**POS REFERENCE: -
POS-P-0173**

**OBJECTION TO PLANNING APPLICATION ON BEHALF
OF [REDACTED]**

REFERENCE: - TP/ED/26/0104

**APPLICATION DESCRIPTION: - Erection of a
secondary school including road access, landscaping,
car parking, sports pitches, recreational areas and
associated development.**

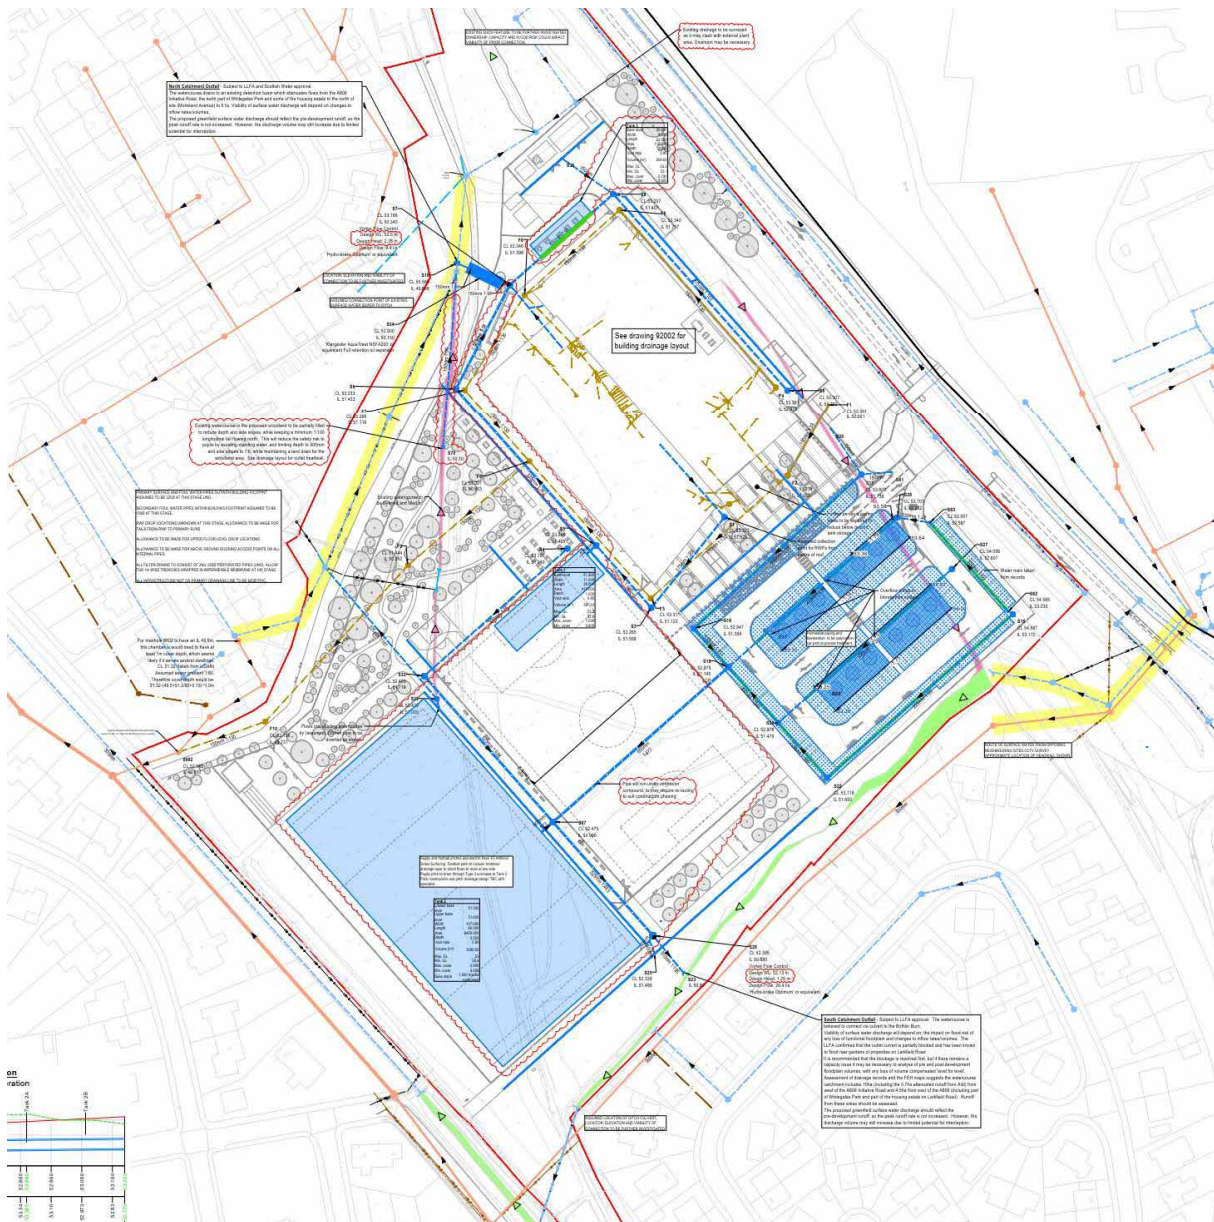
Drainage Strategy Layout (figure 1):

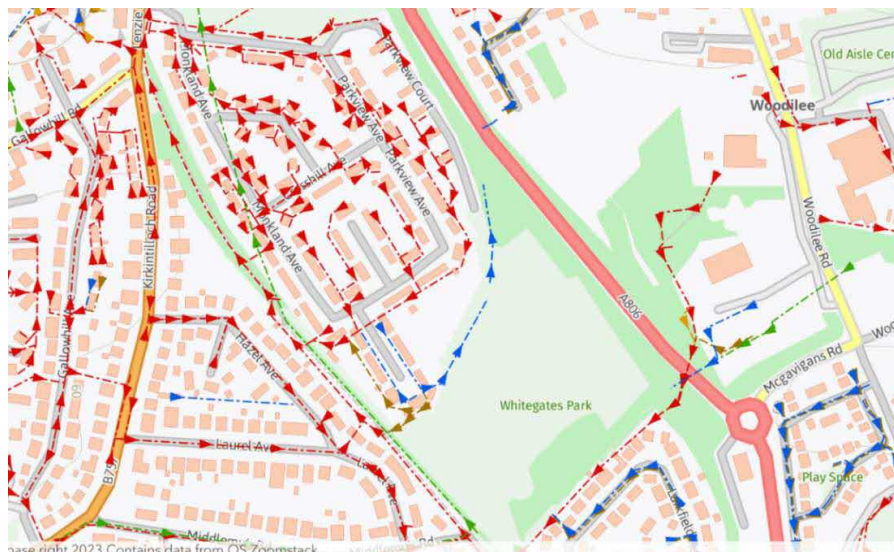
- The report recommends that a Drainage Impact Assessment is carried out by others. It beggars belief that this has not been carried out prior to submitting for planning permission. Again, the question must be asked why this planning application has been validated with so many important aspects of the planning requirements missing.

Figure 1 –site plan showing the location of the site investigation boreholes and trial pits.

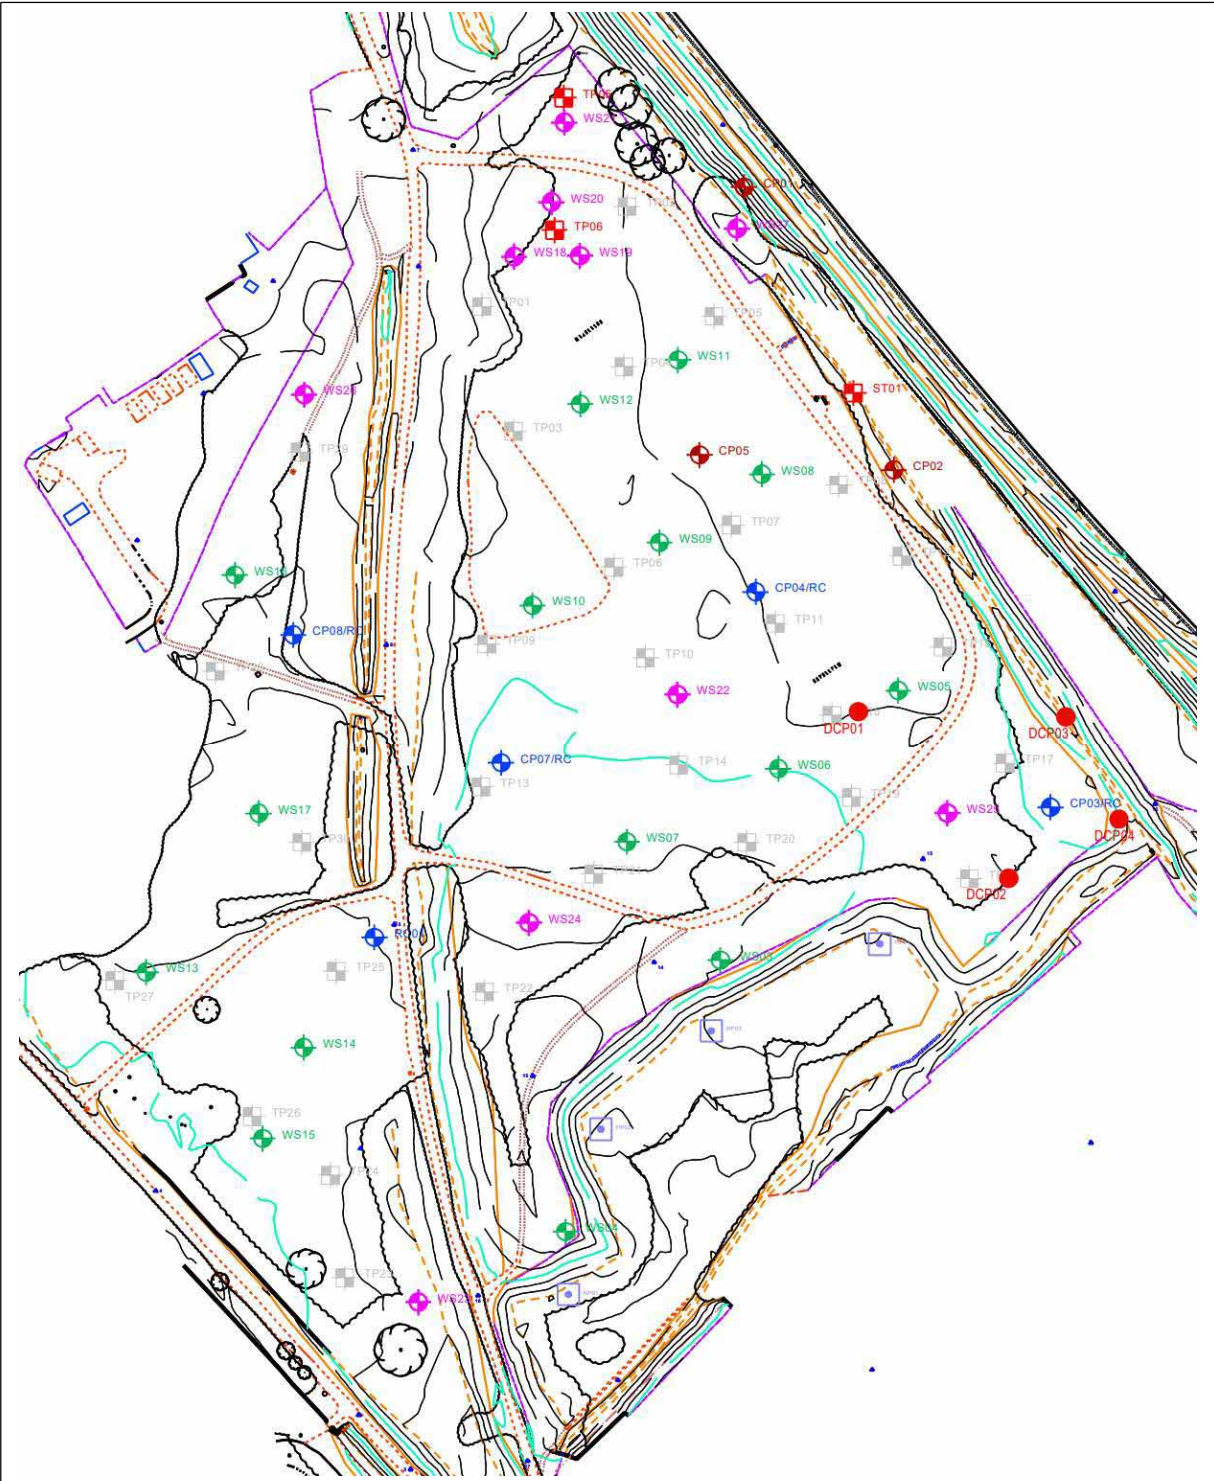
The development site is shown in Figure 1 along with the spread of exploratory boreholes and trial pits carried out for the stage 2 investigation, from which the following summary of difficult engineering conditions encountered across the site have been established.

- A buried peat layer extending to a thickness of 4m thick and in places is buried by 3m of heterogeneous and contaminated fill material. The plan extent of the peat covers over two thirds of the site area, and continues across the east boundary of the site. The contaminated fill material covers the entire site.
- There is a high 'water-table' recorded in almost every borehole and trial pit shown within figure 1.
- The site is encapsulated by varying thickness of contaminated heterogeneous fill material with thicknesses up to 5.0m
- The naturally occurring soils comprise cohesive glacial till and are encountered under the peat or fill material where no peat exists.
- There are large areas of the site impacted by hydrocarbons which caused trial pits to be abandoned and replaced with window sampling boreholes.

Figure 3 - showing the conclusions and recommendations within the stage 1 Preliminary Risk Assessment with no reference to the peat and its associated problems.

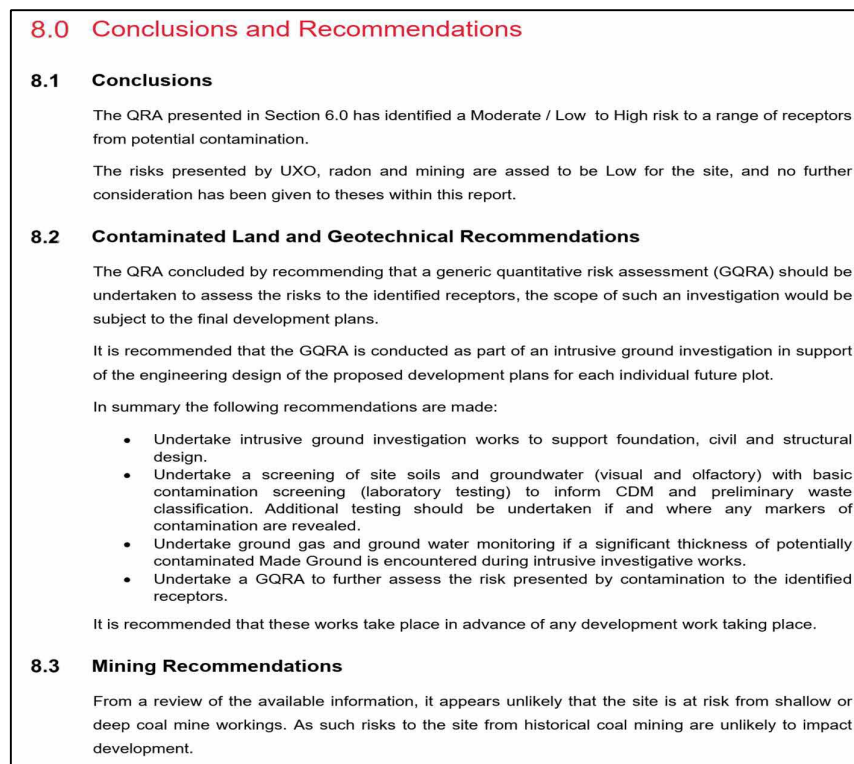
12. It can be seen in figure 3 that the conclusions and recommendations listed with in the Stage 1 Preliminary Risk Assessment do not reflect the very obvious concerns relating to the ground conditions that are highlighted within the report. As stated, the problems associated with the peat should have been highlighted, and then the full extent of the peat should have been identified before embarking on the expensive stage 2 investigation and particularly the planning application. It would be interesting to learn if the Council were aware of the presence of peat on the site prior to listing the site as a possible option for the school upgrade, especially given that the ASN school development proposals for this site were deemed not viable.

Figure 4 –copy extract from the site investigation report list recommendations.

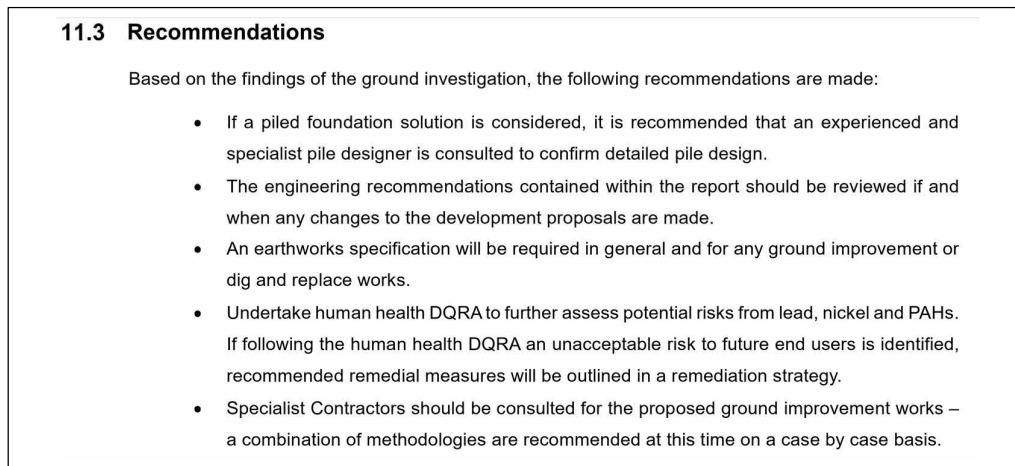
It can be seen from figure 4 that before a piled solution can be finalised, and hence costed, a specialist piling contractor will need to be employed to establish the most appropriate pile for the challenging ground conditions. Displacement piles are typically the most appropriate for peat deposits because there is no excavated material to consider; ie. no peat extraction. However, there will need to be a substantial piling mat installed to safely support piling rigs, craneage, and ground improvement equipment, and it will not be possible to drive piles through the platform without pre-boring first which defeats the purpose. Thus, replacement piles (with casing to deal with the peat) will be required which results in peat excavation, and more than doubles the cost of the piling. **Note, lighting columns and any retrospective building will require to be piled with associated piling platforms etc. and these inevitable ongoing problems of the peat have not been highlighted sufficiently.**

24. It is also advised within the recommendations (figure 4) that a Detailed Qualitative Risk Assessment is required to further assess the potential risks to human health. This is yet a further example of the uncertainty this site presents even after a stage 2 site investigation.
